From: Simon C [REDACTED]
Sent: 07 July 2026 16:59
To: Botley West Solar Farm
Cc: [REDACTED]
Subject: Concerns relating to the Proposed Botley West Solar Farm Cable Route

Concerns relating to the Proposed Botley West Solar Farm Cable Route

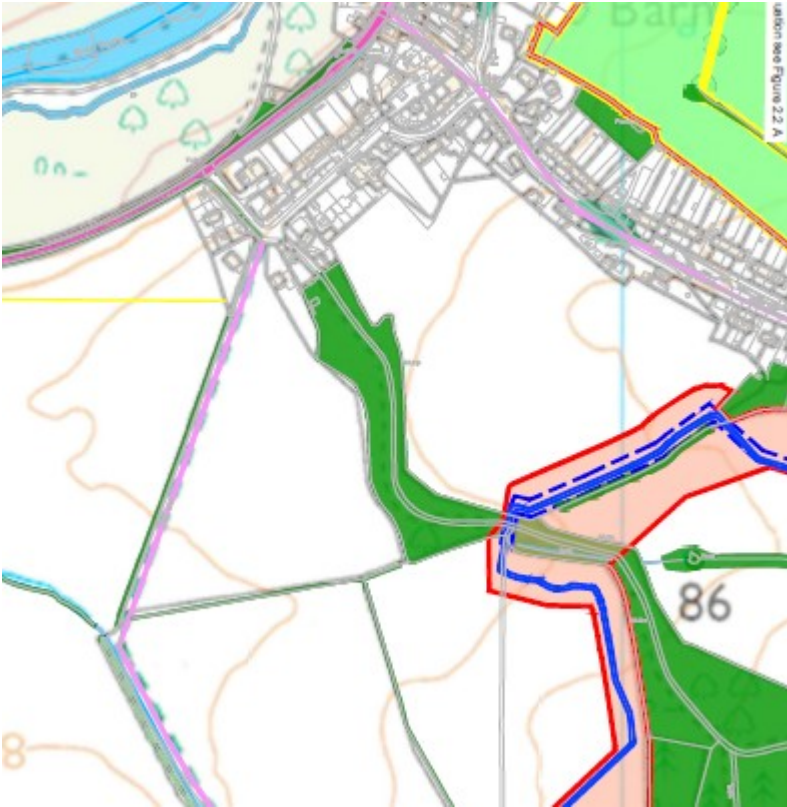
As shown on [Illustrative Masterplan Figure 2.2B \(Central Site Area 2 of 6\)](#), the proposed cable route crosses the woodland track that serves as the only means of access to and from our property. The impact of construction and maintenance activities on this essential access route has not been adequately explained or discussed with us.
